**ALERT SERVICE BULLETIN**

NO. 412-10-139  
DATE Jan 11, 2010  
PAGE 1 of 7

**MODEL AFFECTED:** 412 & 412EP

**SUBJECT:** Inspection of Transmission Oil Line P/N 70-061L000V360A for Correct Length.

FIGURE 1

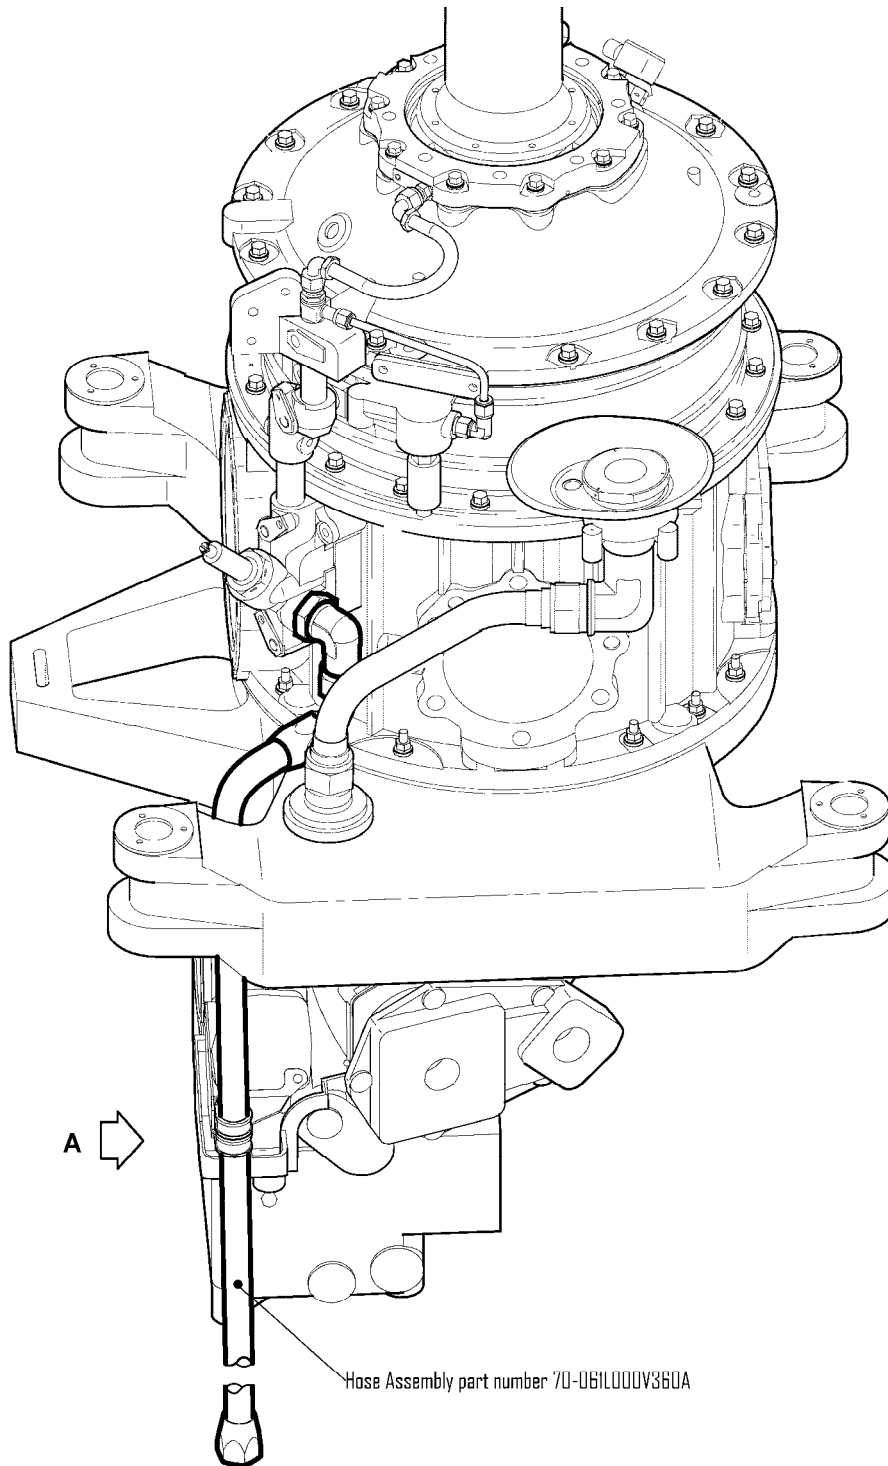
7. Lay the Hose Assembly on a flat surface and measure the length of the Hose as detailed in Figure 1.
8. If the part number 70-061L000V360A Hose Assembly is 36.5 inches (92.71 cm) to 37.5 inches (95.25 cm) then the Hose Assembly must be re-identified, as detailed in step 9.

10. If the Hose Assembly part number 70-061L000V360A measures less than 36.5 inches (92.71 cm) it must be replaced by new part number 70-061L000V370A Hose Assembly prior to further flight.
11. Hoses measuring more than 37.5 inches (95.25 cm) must be replaced by new part number 70-061L000V370A Hose Assembly prior to further flight.
12. Re-install the Hose Assembly and ensure there is no fowling between the Hose Assembly and any airframe components, drive system components, and wiring on the aircraft. See Figure 2 and view "A" for the correct routing of the Hose Assembly.

9. Using a vibrating stylus, vibro-etch a single line through the last four characters of the part number 70-061L000V360A on the tag. Then re-identify the part number of the Hose Assembly as 70-061L000V370AFM.
